Subject: MHI's Response to US-APWR DCD RAI No. 107

Reference: 1) "Request for Additional Information No. 107-1293 Revision 0, SRP Section: 03.09.04 – Control Rod Drive Systems, Application Section: 3.9.4," dated 11/24/2008

Response to Request for Additional Information No. 107-1293,
Revision 0

US-APWR Design Certification- 03.09.04, Control Rod Drive Systems (CRDS)

Figure 1 Applied Area of the Chrome Carbide Coating

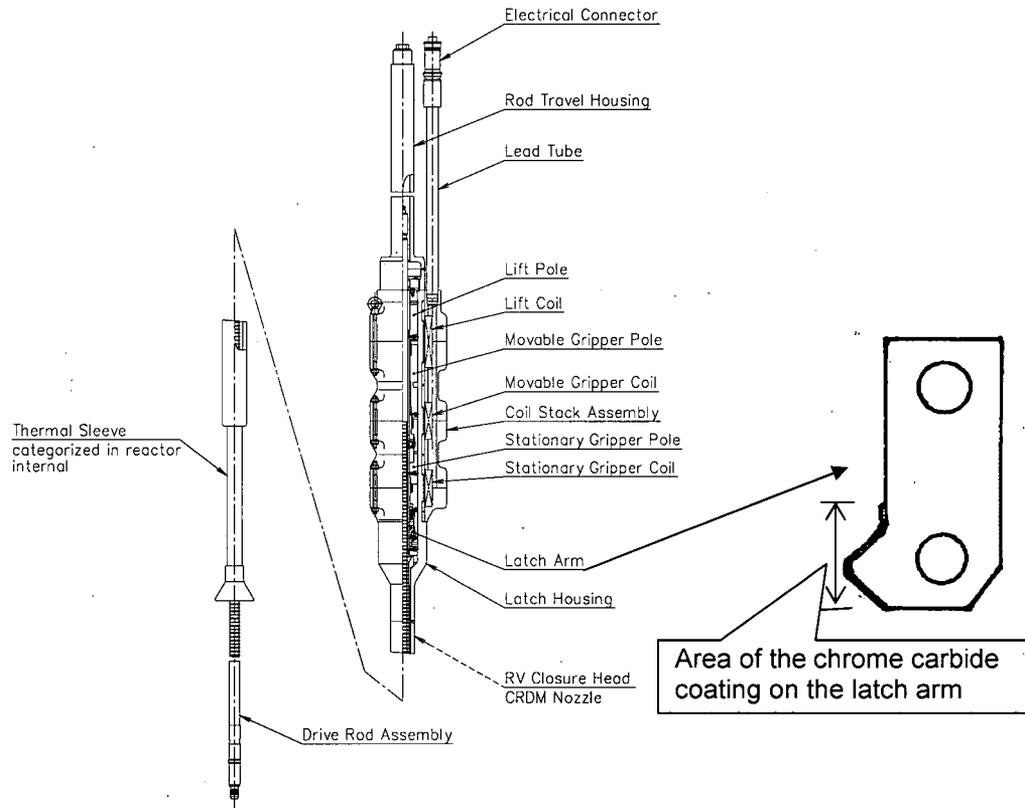
- a. Describe differences between the US-APWR and the previous design, such as the L-106A CRDM and discuss their effects on the applicability of the previous operability tests to the US-APWR CRDM. US-APWR DCD Tier 2, Section 3.9.4.1.1 (page 3.9-56) states that the US-APWR CRDM design is improved by (1) butt welding the CRDM latch housing to the CRDM nozzle on the reactor vessel closure head and (2) applying a chrome carbide coating to the latch arms.

The design of the US-APWR CRDM latch assembly is the same as the previous L-106A type CRDM, except the chrome carbide coating on the latch arms to improve wear resistance. The latch assembly is shown in Figure 1. This design change does not affect operability, since the thickness of the chrome carbide coating is thin enough compared with the clearance between the latch tip and the groove of the drive rod.

Thickness of the chrome carbide coating on the latch arm is [] mils, which is thin enough compared with the approximately [] inch clearance between the latch tip and groove of the drive rod. Therefore, chrome carbide coating does not affect operability.
